Millstone Nuclear Power Station, Unit No. 2
Proposed Revisions to Technical Specifications
Cycle 6 Reload

Technical Specification Changes - Cycle 6 Reload

Discussion of Proposed Revisions
to Technical Specifications

FIGURE 2.1-1 Reactor Core Thermal Margin Safety Limit - Four Reactor Coolant Pumps Operating

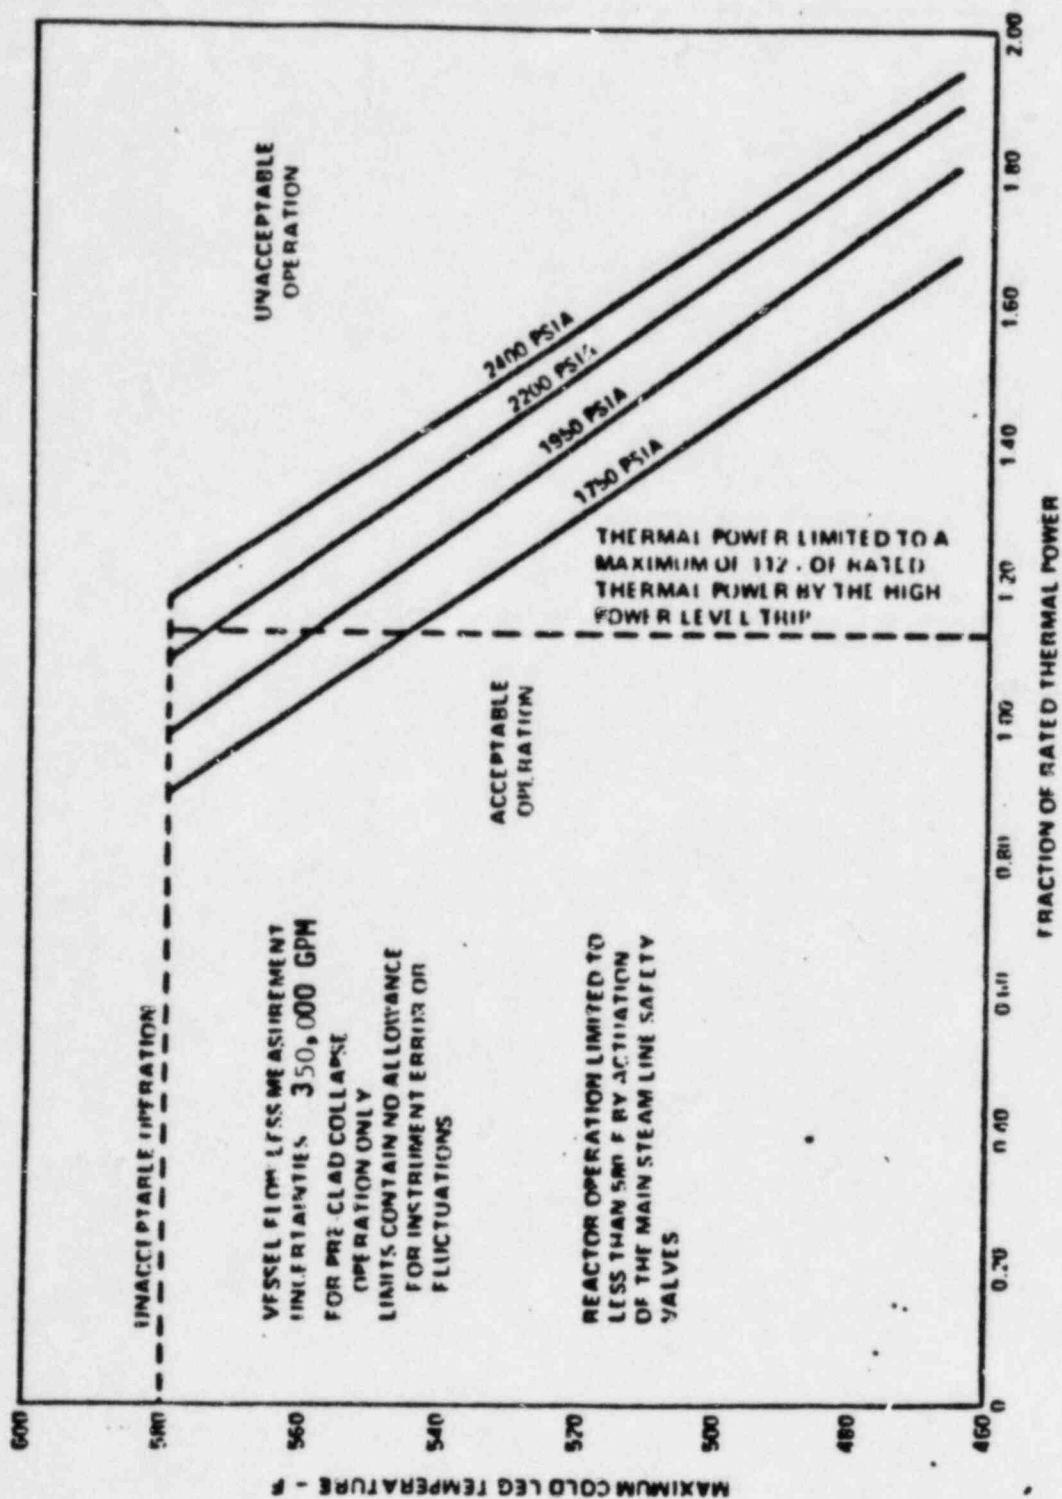
- o Reduced Reactor Coolant Flow Rate - This proposed change effects pp. 2-2, 2-4, and 3/4 2-14 of the Technical Specifications. It involves lowering the required primary coolant flow rate from 362,500 gpm to 350,000 gpm. This new lower flow is established to correspond to a plugging level of 2500 steam generator tubes.

* Design Reactor Coolant flow with 4 pumps operating is 350,000 gpm.

FIGURE 3.2-2 AXIAL SHAPE INDEX vs Fraction of Allowable Power Level
per Specification 4.2.1.2c

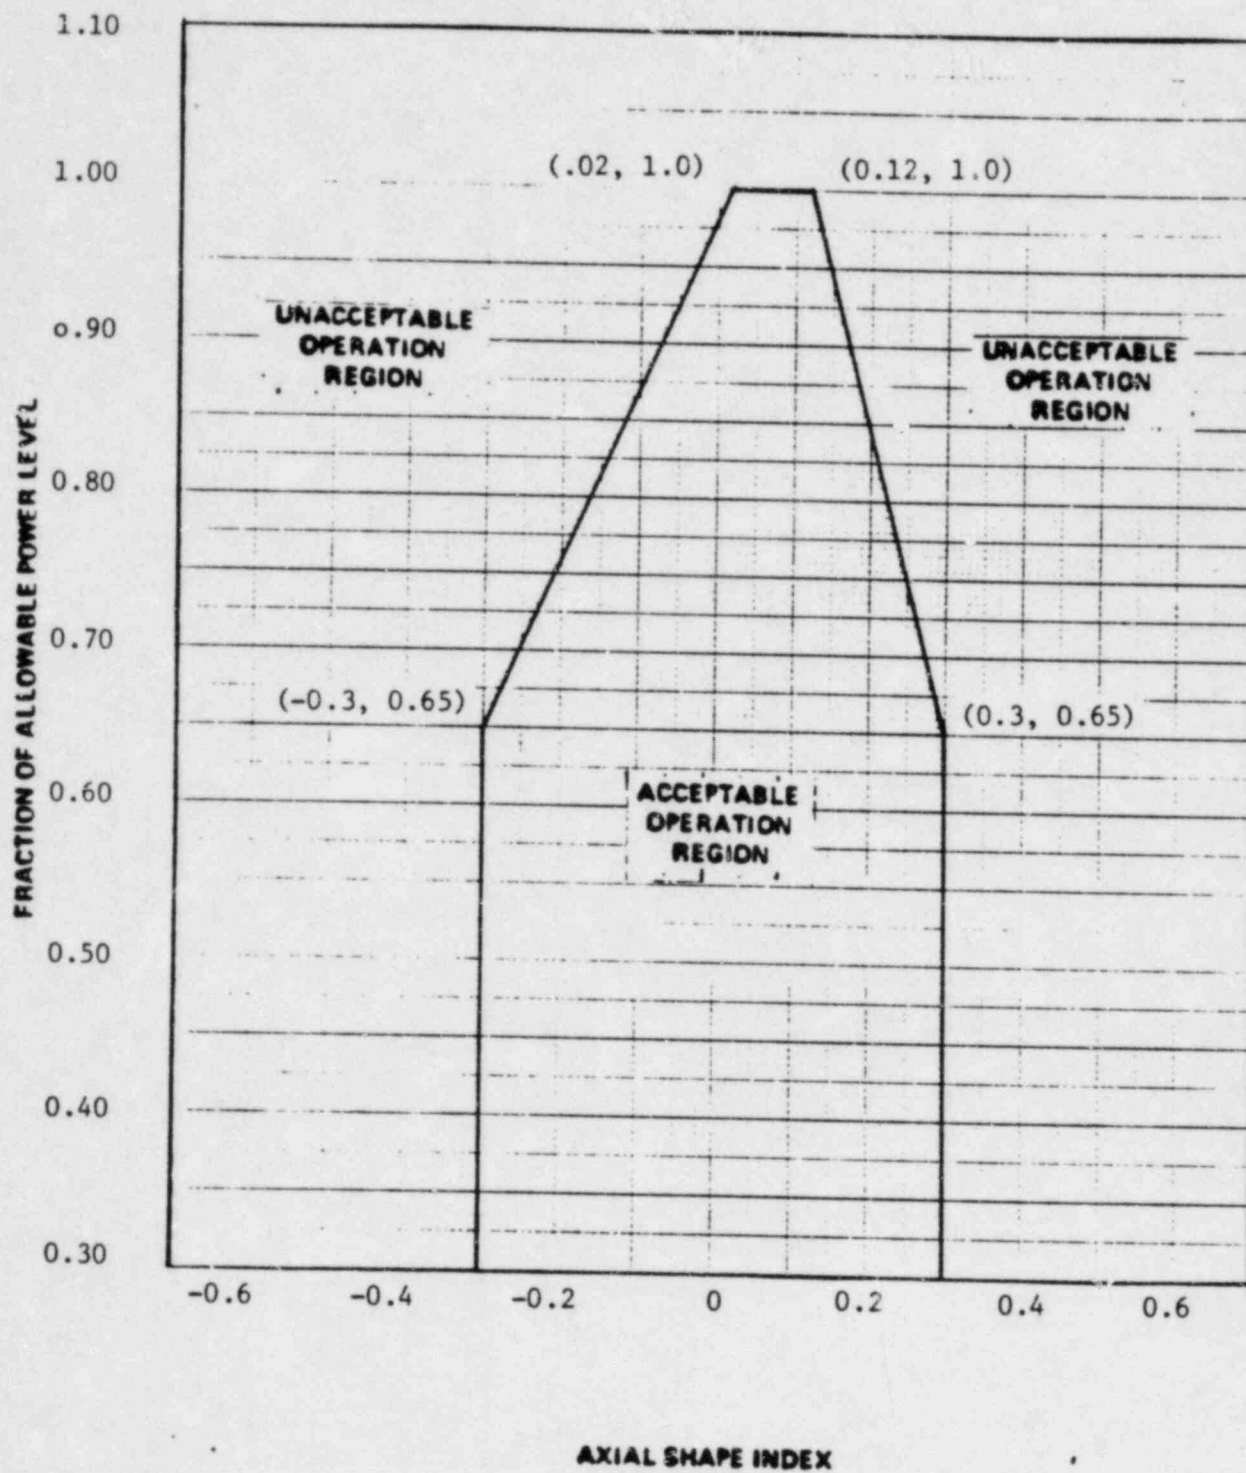
- o New Axial Shape Index Tent - The change to p. 3/4 2-4 involves a new axial shape index (ASI) monitoring tent for figure 3.2-2 of the Technical Specifications. This tent is used to verify the kw/ft limit of 15.6 which is the input to the LOCA analyses. Operation within the tent ensures that the maximum local power is less than 15.6 kw/ft. and thus satisfies the TS surveillance requirement. It should be noted that under normal conditions the kw/ft surveillance limit is verified with the incore monitoring system and the only time the ASI tent is used is if the incore system is inoperable.

FIGURE 3.2-3 Total Radial Peaking Factor Versus Allowable Fraction of RATED THERMAL POWER

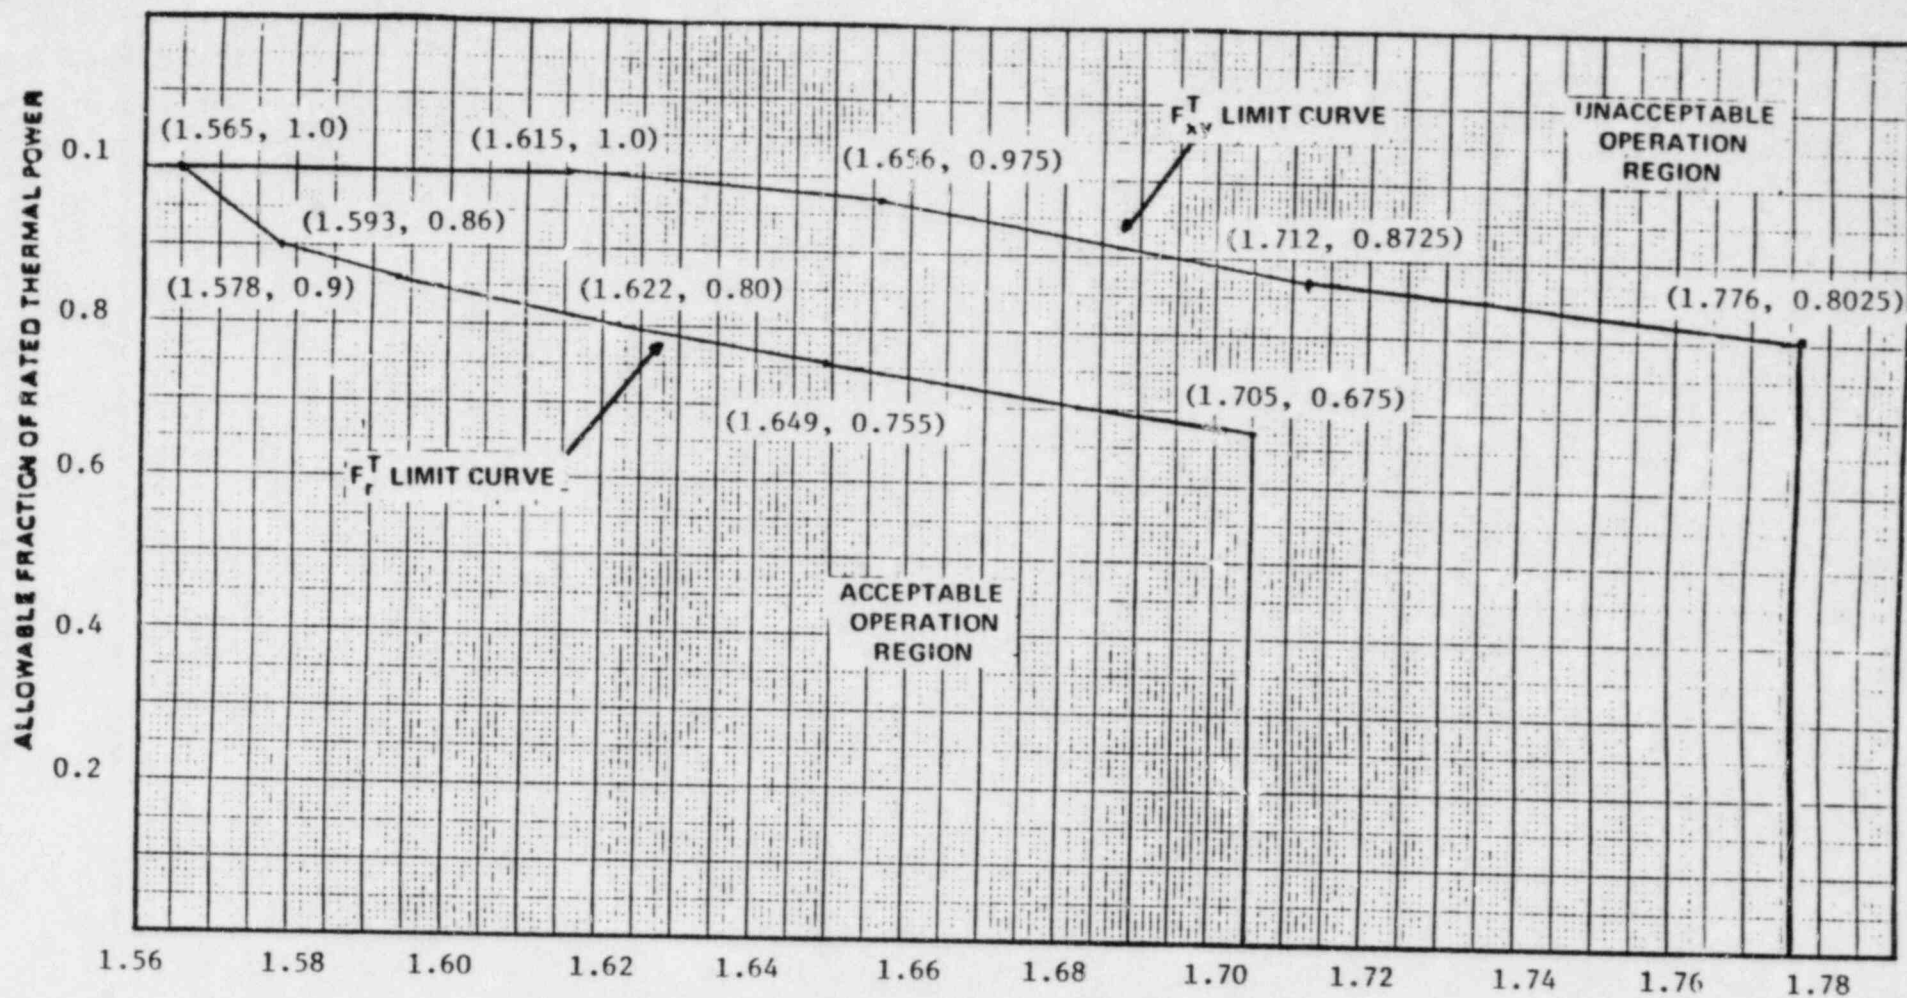
- o Revised total planar peaking factor, F_{xy} , curve - This change effects pp. 3/4 2-6 and 3/4 2-8 of the Technical Specifications and involves restoring the planar radial peaking factor, F_{xy} , monitoring limits back to the original Beginning of Cycle (BOC) 5 values. The Cycle 6 licensing analyses support this proposed revision.

- o Revised total radial peaking factor (Fr) curve - This proposed change effects pp. 3/4 2-8 and 3/4 2-9 of the Technical Specifications. In comparing the BOC 5 values to BOC 6 values, the required primary flow is being reduced by 5.4% (370,000 gpm to 350,000 gpm). Although the current licensed primary coolant flow rate is 362,600 gpm, BOC 5 values are being used since these values correspond with those of the last transient analysis. The Cycle 4 Reload Safety Analyses have shown that the DNB analysis penalty which results from a reduction of 2% in primary flow can be offset with an approximate 1% reduction in Fr . Therefore, the 4% reduction in allowable Fr more than offsets the penalty associated with a 5.4% reduction in primary flow. The Cycle 6 licensing analyses support this proposed revision.
